Our Ref: 2112XX-20458-Prelim BCA Review

BCA REVIEW			
Project Title:	BCA AUDIT		
Project Address:	39 THE AVENUE, BALACLAVA		
Reference No.	20458	Date:	17 JANUARY 2022

BUILDING PROJECT PROFILE	
Site Name:	The Avenue Childcare Centre
Property Address:	39 The Avenue, Balaclava
Description of Works:	Site inspection
BCA Version:	2019 Amendment 1
Classification:	Childcare – Class 9b
Use:	Childcare
No. of Storeys:	1
Rise in Storeys:	1
Type of Construction:	Type C
Effective Height:	Not applicable
No. of Occupants: (BCA D1.13)	41 children 10 staff
Floor Area:	278.01m ²

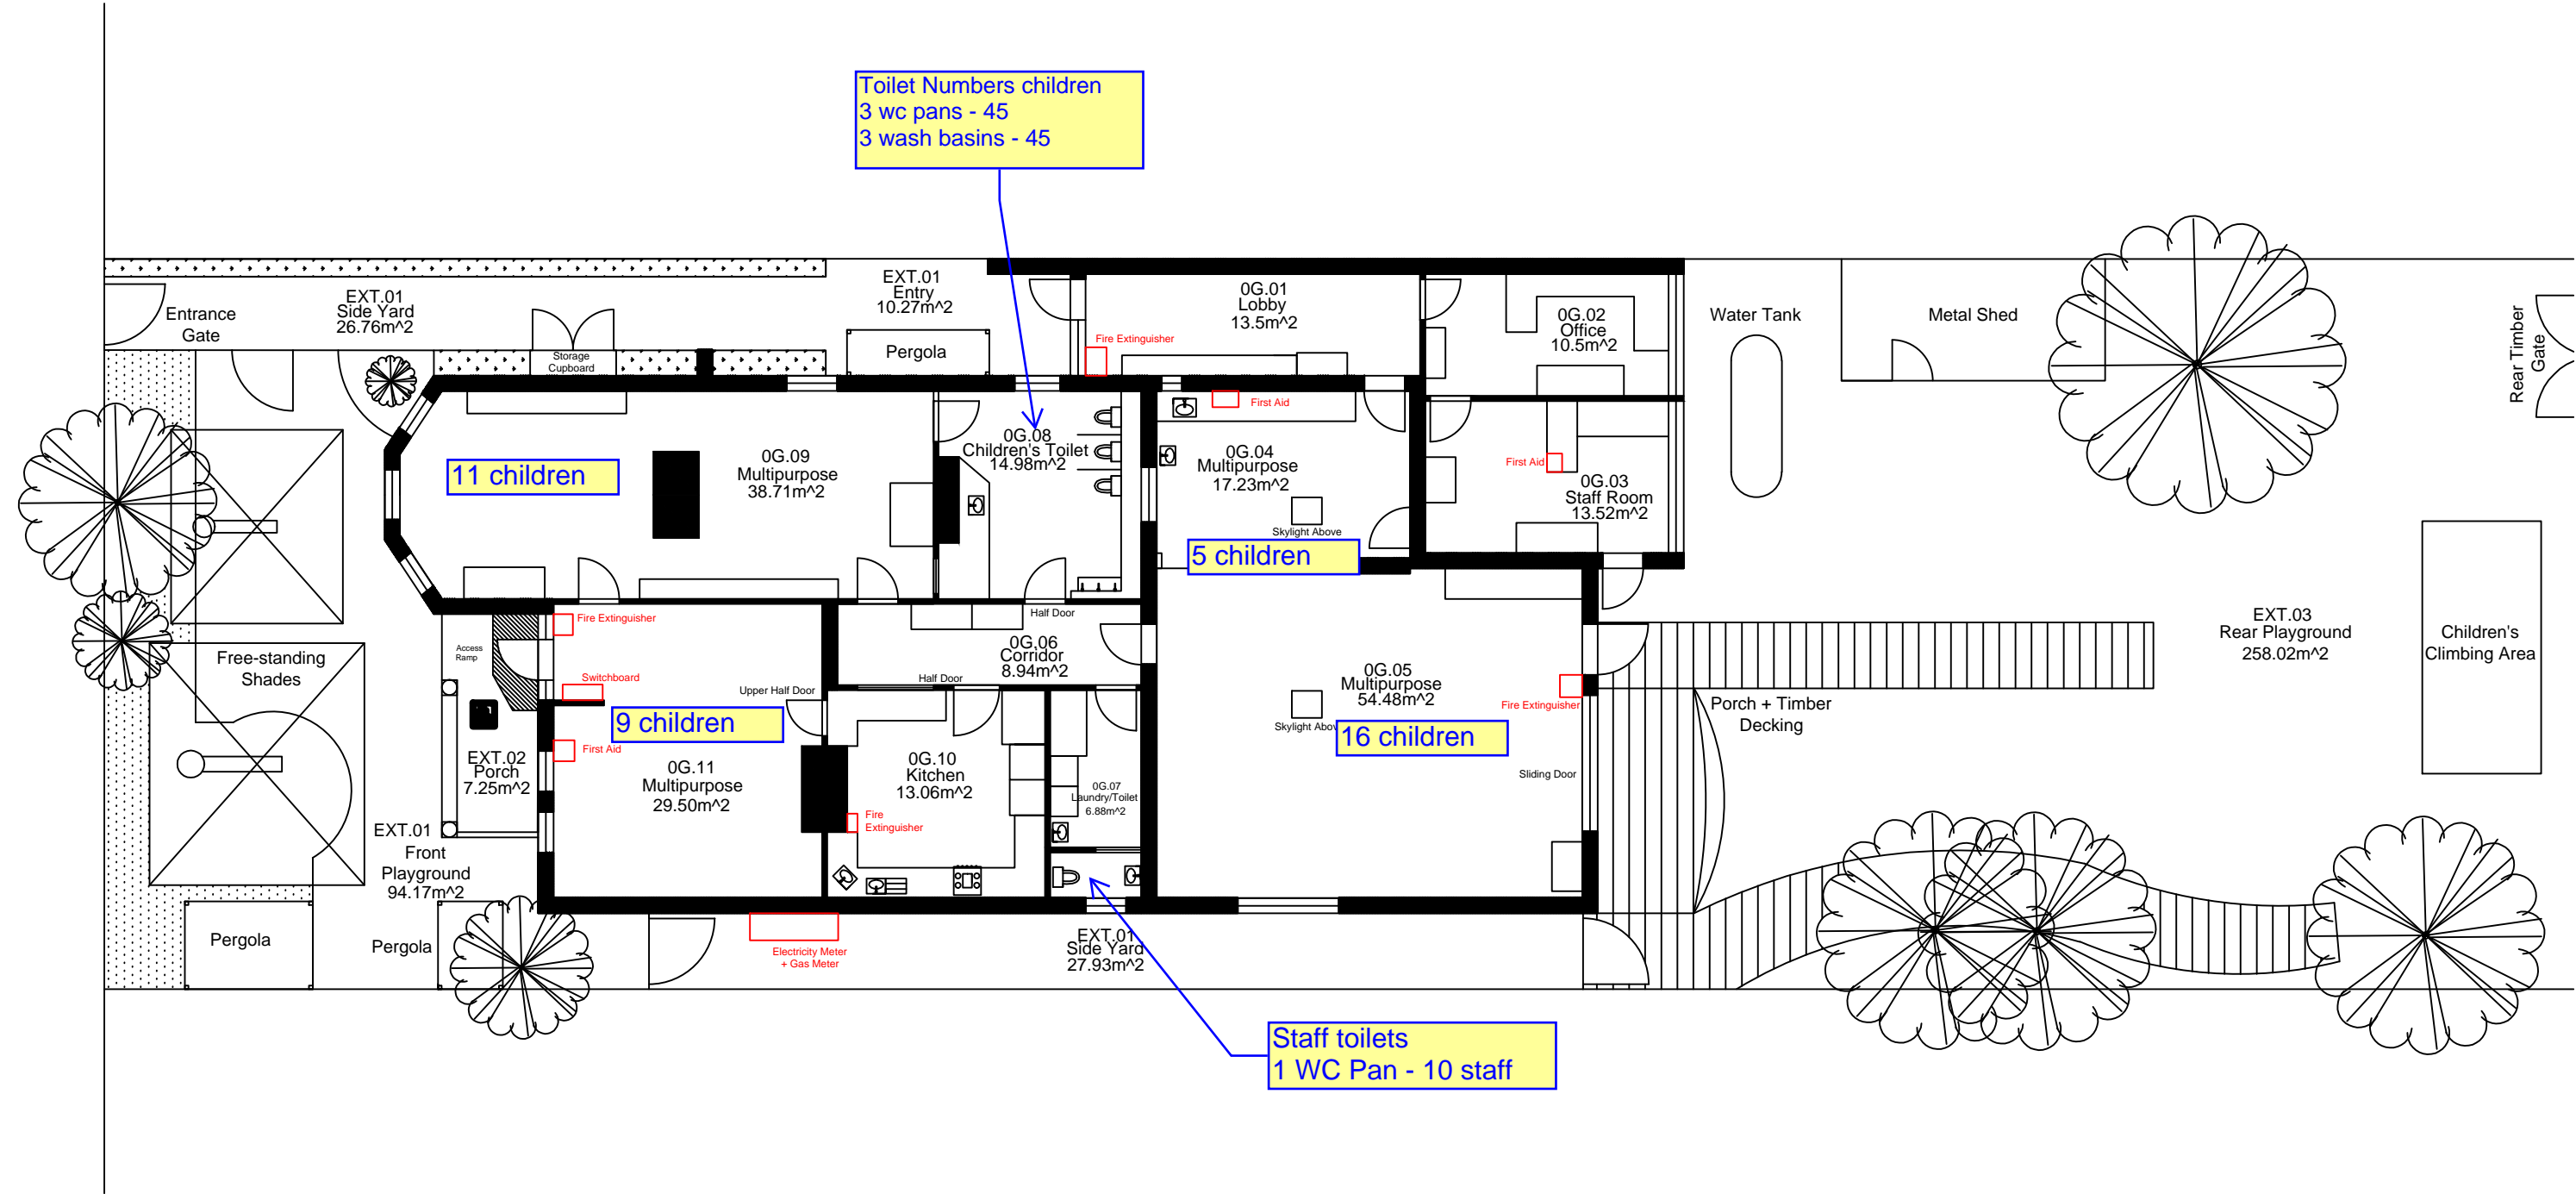
F1.7	Waterproofing of wet areas	Walls and floors within wet areas required to be waterproofed	All wet areas have water resistance material such as tiles and vinyl. Laundry did not have water resistant splashback. Could not determine compliance with BCA provisions in the absence of destructive testing and manufacturers specifications. .
F2.2	Calculation of number of occupants & facilities	Require to provided separate male and female facilities. Faculties are not permitted to be shared between children and staff.	Toilet facilities provided have only a unisex toilet. However, this toilet does not comply with AS1428.1 provisions.
